PLANNING REPORT

Planning & Zoning Commission

Thursday, September 5, 2024

Irish Village 24-106CP

Concept Plan

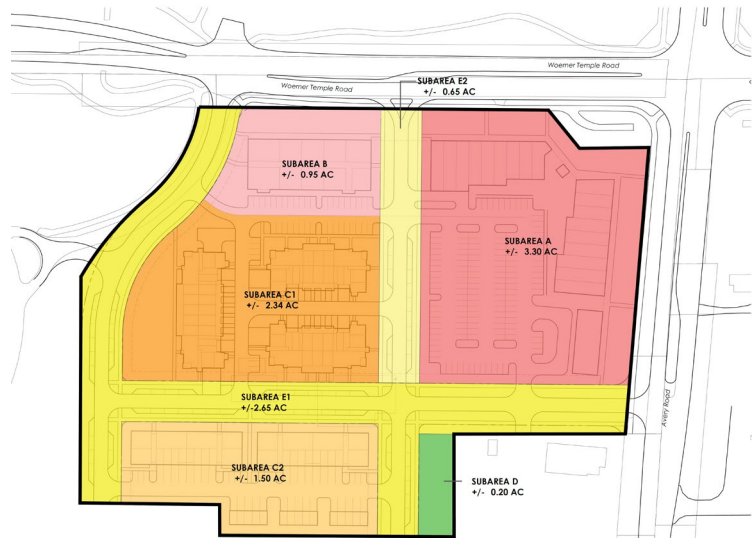
It should be noted that neither of the intersections of Streets B and C, along with the existing public roads, meet the desired intersection spacing. The Street B/Avery Road intersection would also conflict with existing curb cuts on both sides of Avery Road. In addition, as proposed, Street A would require realignment of the pool access drive and a retention basin, which are

currently located on city-owned property. Previous plans for the area envisioned a public street in this vicinity, although the details (including the use of city property) would have to be further studied. If the project moves forward to the PDP/Rezoning stage, a Traffic Impact Study (TIS) would be required. The access points would be finalized along with the associated traffic control through the study process, and any off-site improvements would be identified. The scope of the TIS shall be established through a Memorandum of Understanding to determine the specific needs and evaluations for the site.

2) Is the Commission supportive of the proposed site layout?

The Concept Plan organizes the development around a public/private street grid with tree lawns, sidewalks and other amenities. A 50' setback is proposed along the road frontages. As noted above, the roadway character in the Thoroughfare Plan contemplates a 100-foot or equivalent setback along Avery Road, and generous setbacks of 100-200 feet along Woerner Temple Road to maintain a rural character. During the Informal Review, Commission members expressed willingness to accept smaller setbacks as long as patios or other amenities were incorporated to activate the frontage while maintaining view corridors to the adjacent parks. The applicant is proposing green infrastructure/natural landscaping within the setback, along with walkways, patios, stone walls and other amenities consistent with several roadway character recommendations. The Commission should consider whether the proposed setback/treatment is appropriate.

Subarea Diagram

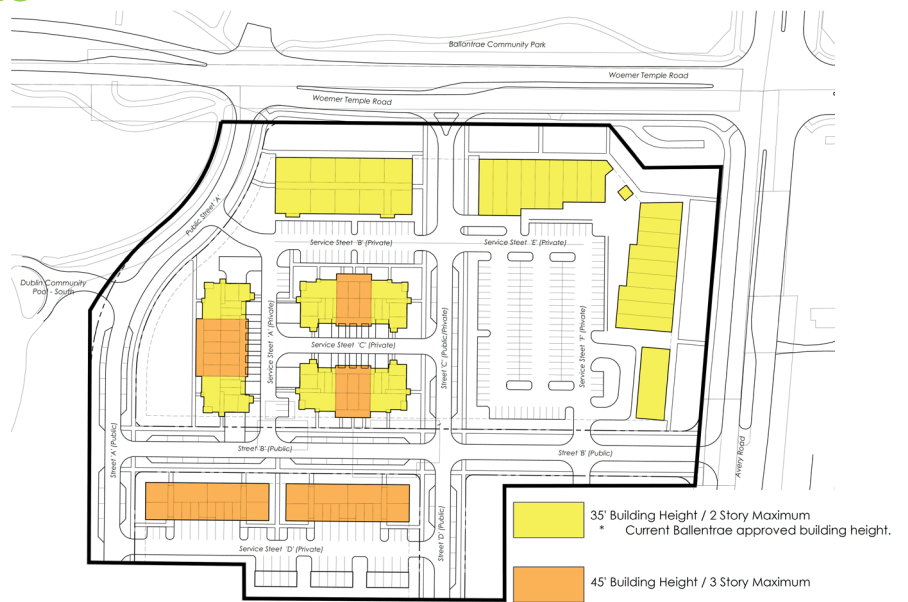
This subarea would occupy ± 3.30 acres in the site's eastern half and include neighborhood commercial uses. It should be noted that, unlike the Informal Review version, this proposal incorporates up to two potential drive-through/drive-up businesses. Parking is internal to the site and is proposed to be screened by the stone walls and amenities. The drive-through lanes would be accessed from within the parking lot, although the northern one (near the Woerner Temple Road frontage) does not appear to allow sufficient stacking.

1) Is the Commission supportive of the inclusion of drive-through/drive-up facilities and the potential wholly residential building along Woerner Temple Road?

As noted above, the Community Plan envisions a mixed-use neighborhood at this site that is accessible by car but is designed as a walkable neighborhood that is pedestrian-scaled. During the Informal Review, Commission members expressed overall support for the mix of uses, but drive-through/drive-up facilities were not contemplated. In addition, the proposed building in Subarea B (along Woerner Temple Road) could either house a mix of uses or be exclusively occupied by multi-family residential units. The Commission should consider whether including drive-through/drive-up facilities is appropriate and if a wholly residential building is acceptable along the Woerner Temple Road frontage.
